52A, NORTH HILL,
LONDON,
N6 4RH

HERITAGE NOTE:

Appendix I, Design & Access
Report by ME Architects, April
2024

Response to request for information for the above site ,
a Grade II Listed former coach house in the Highgate
Conservation Area, by the London Borough of Haringey

Figure 1 – Existing plans of the areas affected by damp. Key plan for the associated condition schedule.

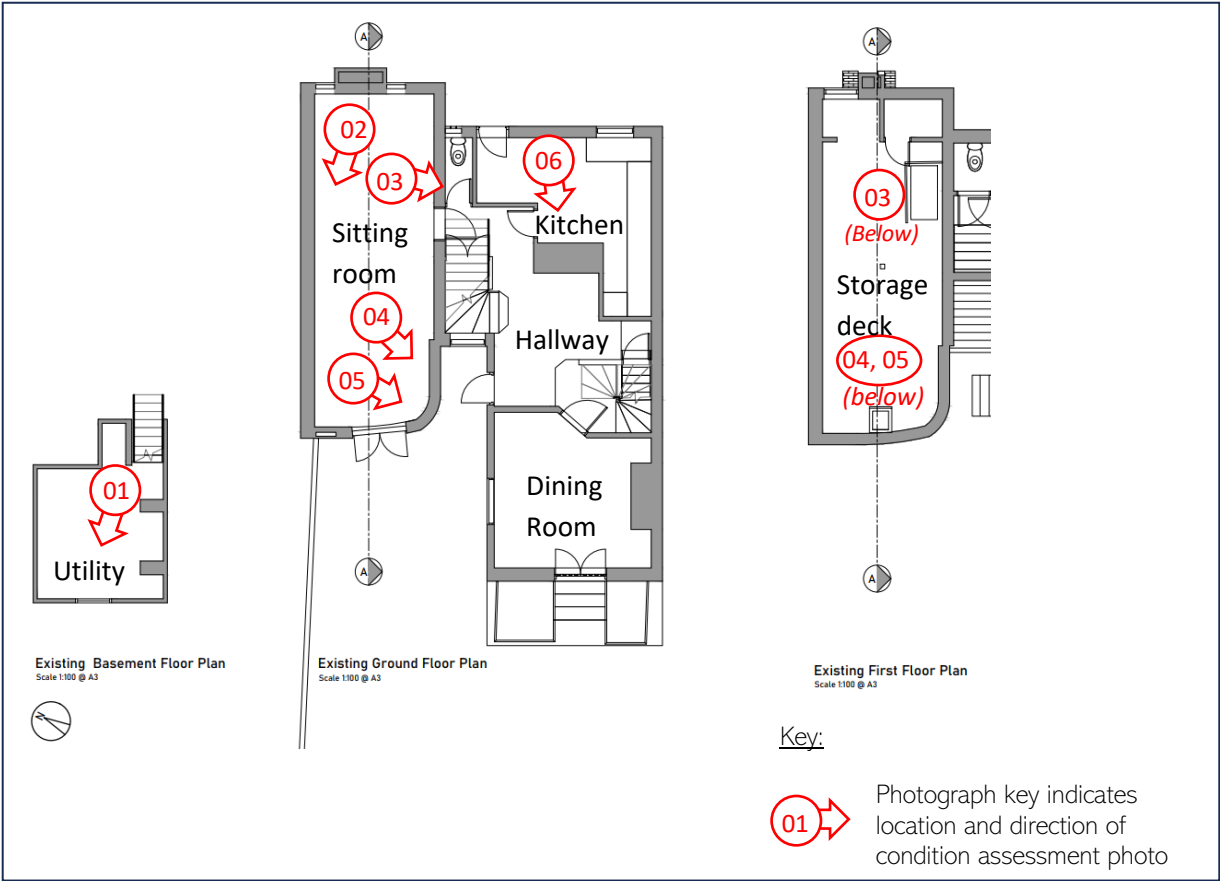
Section	Comment	Response
Listed Building/ Internal works		
'Damp proofing'	<i>'The proposed damp proofing works as outlined in the report are very intrusive and there is little information presented to support this approach to remedying the</i>	See section 2.1

<i>condition of the building. Ensuring the condition of the building, including reducing water ingress and damp, is important for conserving the building, however an alternative approach, and a more thorough investigation of the building itself is recommended.'</i>	
Works to the 'north wing'	<i>'The north wing of the building is understood to have been a stable/coach house, potentially with a hayloft accessed by the remaining ladder. The existing finishes are modern, and it is unclear whether or not any of the historic hayloft structure or other features are concealed in the modern floor build up. There is no in principle objection to the removal of a modern floor, but if any historic floor remains then this should be retained. Additionally, there appears to be a couple of posts which rest on the floor which would be removed. It is recommended that these are also investigated whether they are structural and what they rest on. Their removal/adaptation would be dependent on if they are modern, and on the design for a suitable solution. The existing ladder should remain exposed, any fitted furniture including kitchen counters should not conceal this feature. It was discussed that the available head height on the existing attic is low, it is recommended that they have a discussion with building control on the acceptability of head height.'</i>	See section 2.2

The proposed damp resolution methods are principally associated with rectification of the current (suspected) leaks and defects. These include rainwater, gutter and (assumed) external wall defects. The building pathology will be investigated to determine the exact sources of the damp and following fixing the defects, the building will be dried out and reviewed.

For additional protection (to ensure the building's fabric is preserved), a damp proof membrane with additional dry lining / finishes is proposed to the basement. This system is non-invasive and has been approved in Grade I buildings (evidence can be provided).

Figure 9 – Ceiling opening, recording

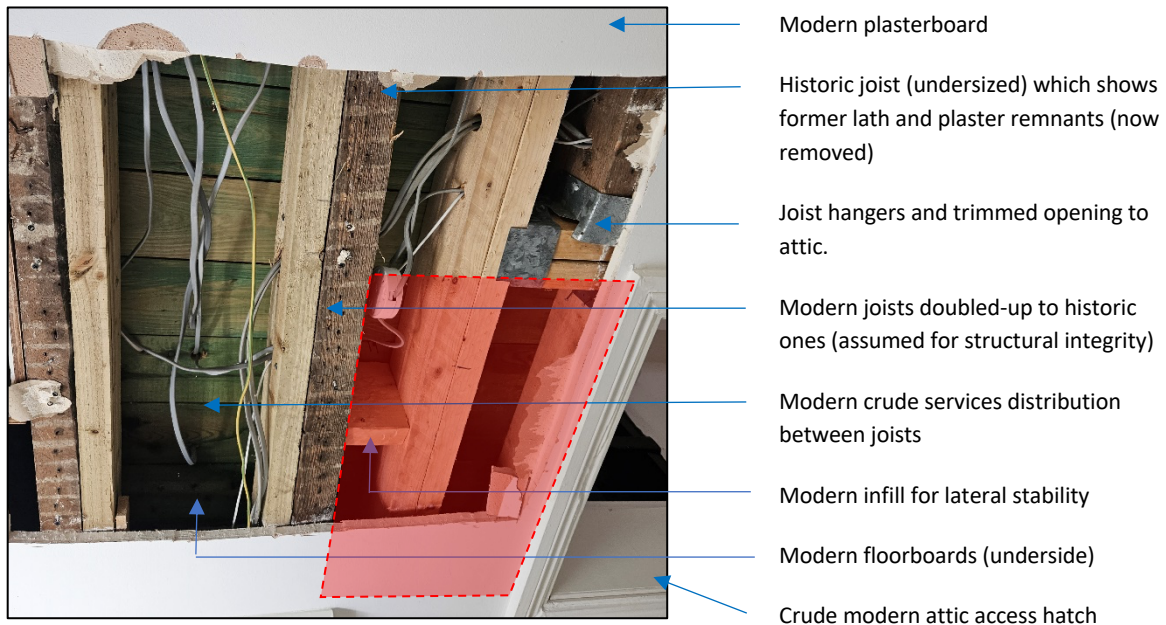
'The north wing of the building is understood to have been a stable/coach house, potentially with a hayloft accessed by the remaining ladder. The existing finishes are modern, and it is unclear whether or not any of the historic hayloft structure or other features are concealed in the modern floor build up. There is no in principle objection to the removal of a modern floor, but if any historic floor remains then this should be retained. Additionally, there appears to be a couple of posts which rest on the floor which would be removed. It is recommended that these are also investigated whether they are structural and what they rest on. Their removal/adaptation would be dependent on if they are modern, and on the design for a suitable solution. The existing ladder should remain exposed, any fitted furniture including kitchen counters should not conceal this feature. It was discussed that the available head height on the existing attic is low, it is recommended that they have a discussion with building control on the acceptability of head height.'

Targeted opening-up has been undertaken (from below) to the hayloft's floor. It has revealed extensive alteration and very little remaining historic fabric. The opening has been labelled on the photograph below. The proposals have been altered based on the pre-application feedback. The original hayloft ladder will be displayed and the kitchen arrangement has been altered accordingly.

The floor structure is no longer proposal for removal (see architect's drawings) – nor is the previously suggested extension of the roof hatch opening (see red area hatched, below).

Similarly, the posts mentioned are no longer proposed for removal. It is assumed that the revised proposals address the pre-application feedback concerns as the proposals have been altered to address each issue raised.

Opening-up Report – Heritage Assessment

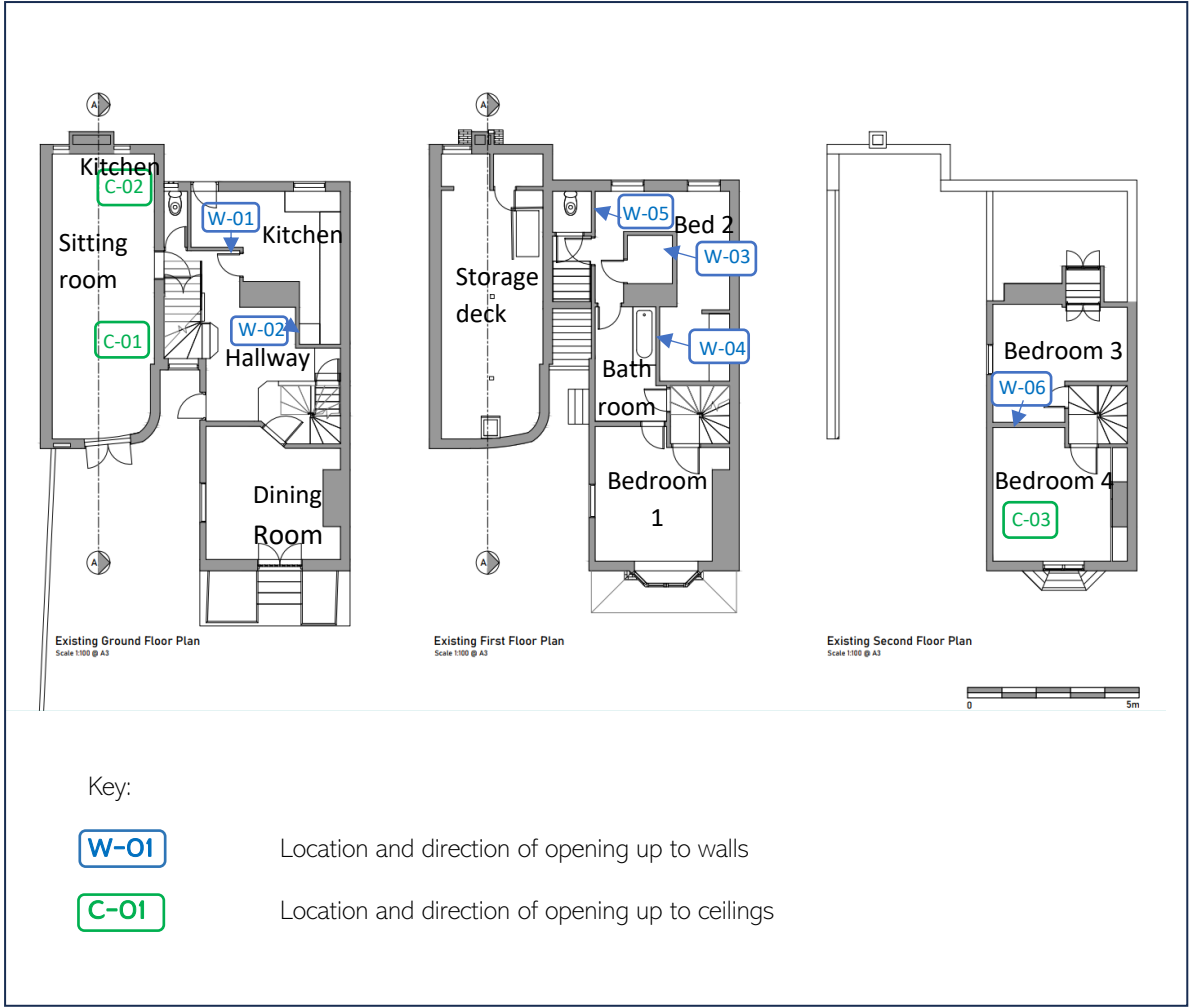
Some of the walls in the floorplan as shown appear to be modern interventions, as discussed in the submitted heritage statement. There is no in-principle object to the removal of modern partition walls. However, if some of the walls may be more historic, then their loss through the loss of historic fabric and planform) may be considered to cause some harm to the significance of the listed building. It is recommended that sufficient investigation into the age and significance of the walls proposed to be demolished is undertaken.

We have provided full interpretation of the opening-up on heritage terms below. In doing so, we have demonstrated that the areas proposed for removal or demolition are of no historic significance.

The opening-up work findings have been included in the architect's supporting information. The openings have been assessed in terms of historic significance herewith:

Wall (trial) openings are shown in blue.

Ceiling (trial) openings are shown in green.

Opening	Room	Photograph	Findings
C-01	Sitting room		Ceiling opening indicates that the historic joists have had to be doubled up for structural integrity. It is assumed that there is other modern infill. Finishes are entirely modern, no lath and plaster remains. No action.
W-01	Kitchen		Entirely modern masonry wall comprising blockwork with gypsum plaster 30mm approx and skim

W-02	Ground floor hallway		Entirely modern masonry wall comprising blockwork with gypsum plaster 30mm approx and skim.
W-03	Bedroom 2		Entirely modern studwork wall comprising 2 layers plasterboard / insulation board each side with rockwool between modern timber studs. <u>Studwork is labelled with timber specification showing modern soft wood present as seen on photograph.</u>
W-04	Bedroom 2		A continuation of the wall above albeit that this hole does not reveal the studworks (hit and miss openings).
W-05	Bedroom 2		Entirely modern studwork wall comprising 2 layers plasterboard / insulation board each side with rockwool between modern timber studs.

W-06	Bedroom 3		Doubled-up timber studs (modern against historic) with rockwool insulation infill and plasterboard finish. The doorway will be made in the red section, no historically sensitive fabric will be removed. Studs shown within proposed doorway are modern. ↓ indicates Historic joists ↓ indicates Modern studs
C-02	Sitting room	See section 2.2	See section 2.2
C-03	Bedroom 4		2 layers plasterboard with insulation boards spanning between ceiling joists that have been adapted with hangers. New modern timbers doubled up to historic ones. See section 2.4
